CITY OF PORTLAND, MAINE
HISTORIC PRESERVATION BOARD

**WORKSHOP
41 BOWDOIN STREET**

**WORKSHOP
714 STEVENS AVENUE
UNIVERSITY OF NEW ENGLAND**

EXHIBIT 2

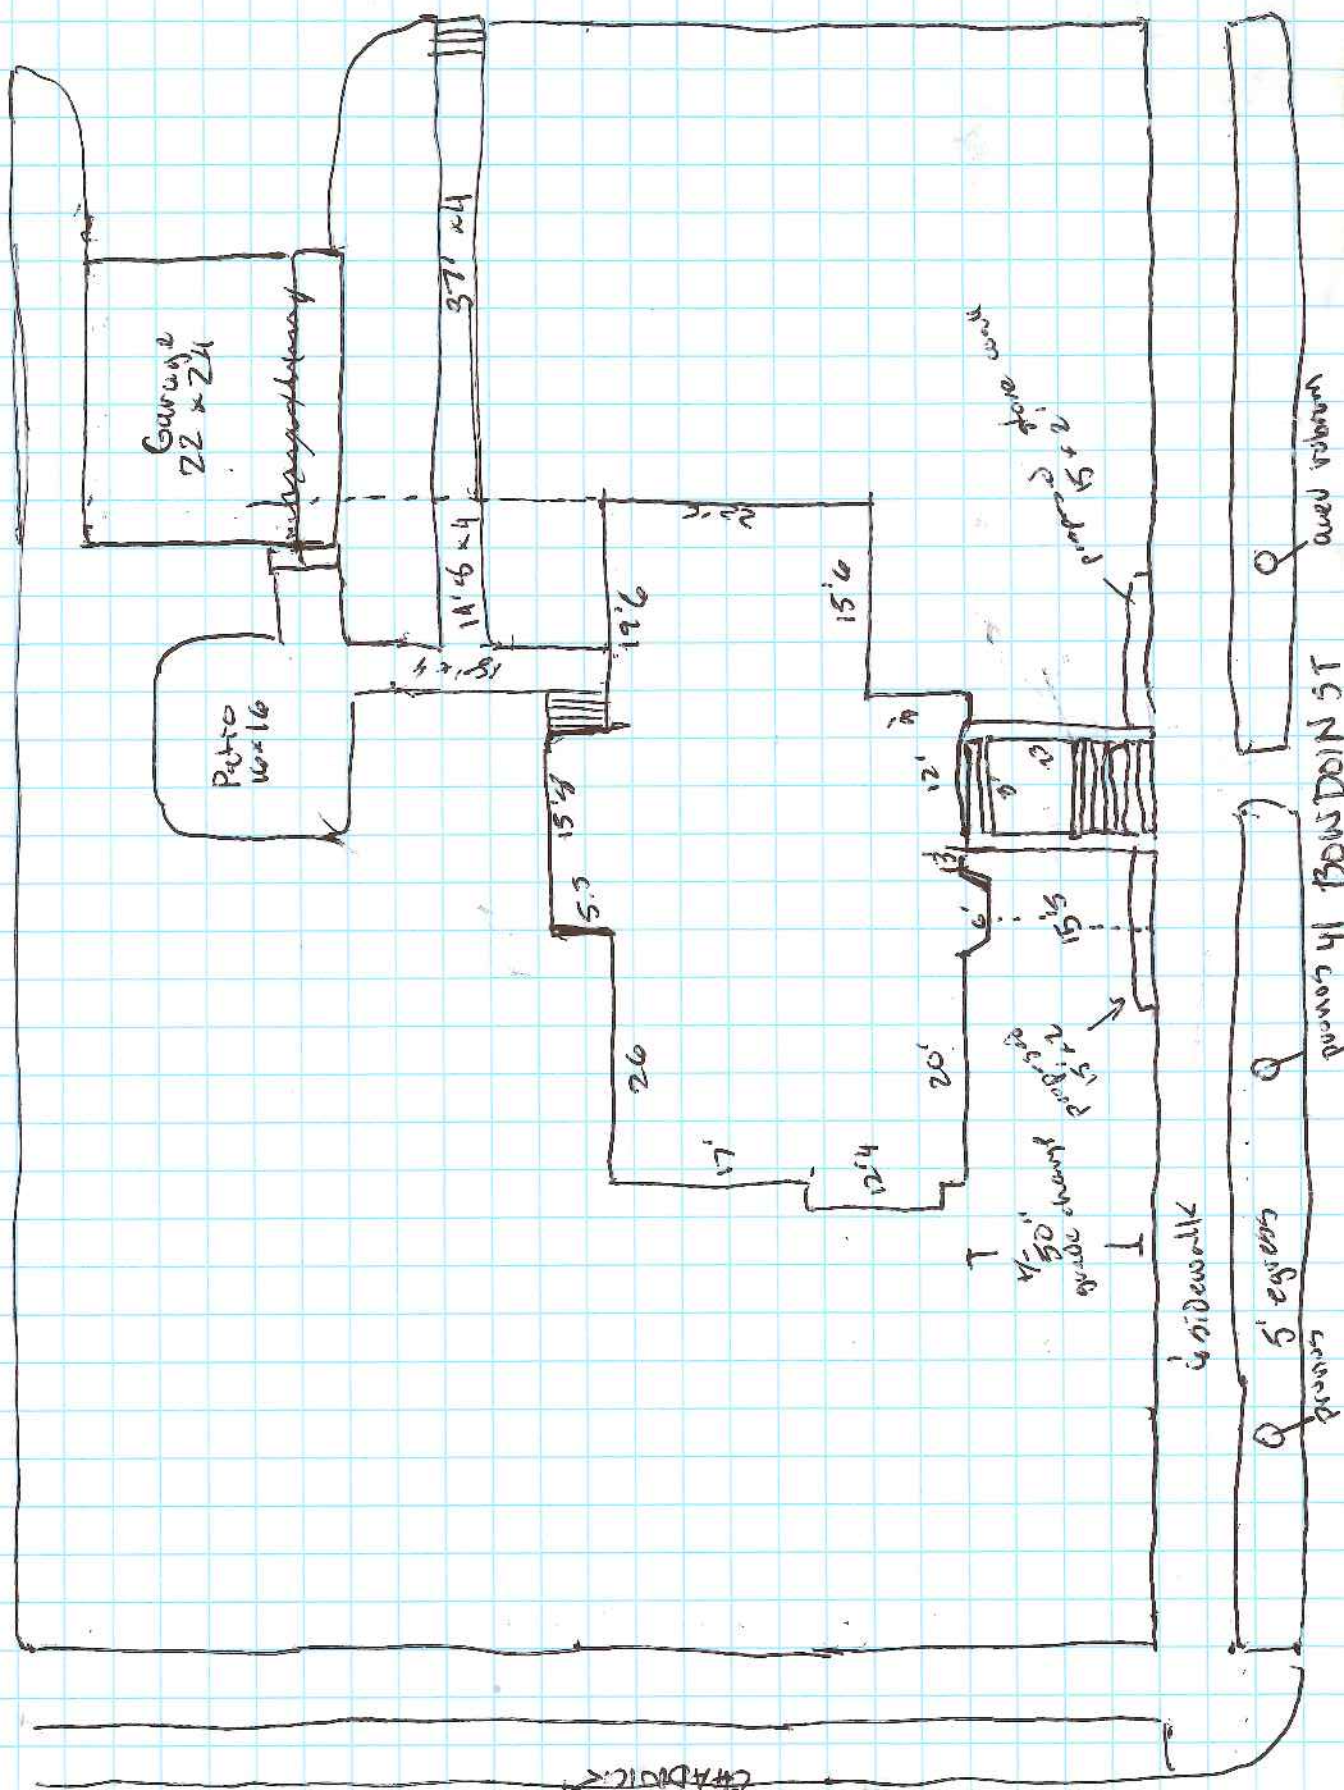
Danas agreed. The contractor's drawing of the proposed walls is included with the application materials; note that it is based on his "before" panoramic camera image that makes the straight edge of the front boundary appear curved. The proposed project is not on a corner, as it appears in the before photo and the rendering by Mr. Monsell. Mr. Monsell also supplied a site plan, and staff has included photos taken after the wall construction was under way, as well as photos of the Bowdoin Street context. Mr. and Mrs. Dana have also supplied photos showing a variety of front retaining walls in the West End, which will be displayed at the meeting.

NORTH GREEN ENTRANCE
SCALE: 1/4"=1'

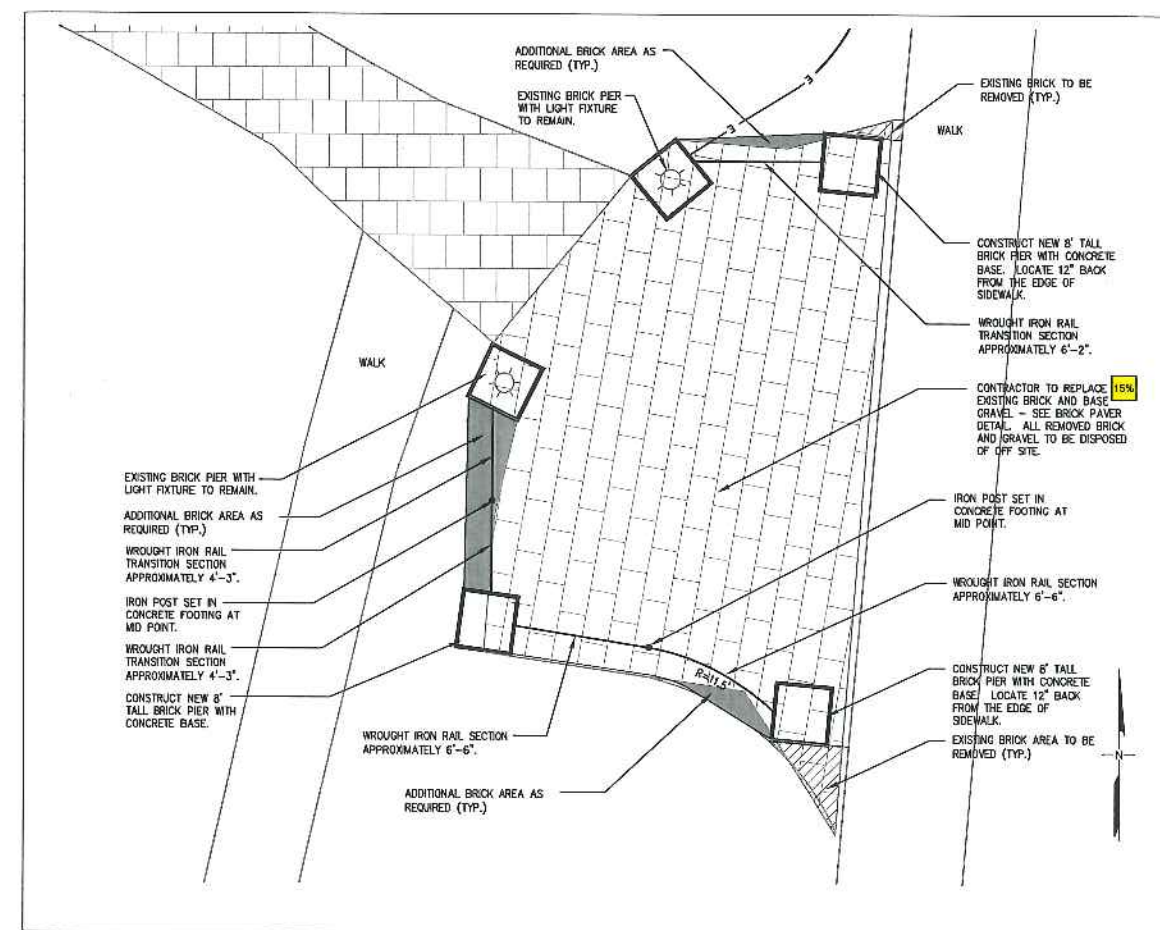
The UNE campus is not enclosed by a fence bordering Stevens Avenue, which helps explain the university's motivation for both the 1997 project and the current proposal. Though a rendering has not been included with the submission, one can imagine the additional piers and fencing accentuating the pedestrian entrances, and narrowing like a funnel at the start of the walkways. The investment in small amounts of iron fencing with robust piers for these two campus entries inspires one to ask whether UNE hopes to eventually make a much more significant investment in fencing for the campus border.

- Would it be worth considering slightly narrower new piers – proportionately lighter – to match their lower height, as compared to the existing piers?
- It does not appear that the proposed piers include lighting. Are there changes to seating, lighting, or signage that would be associated with this proposal?
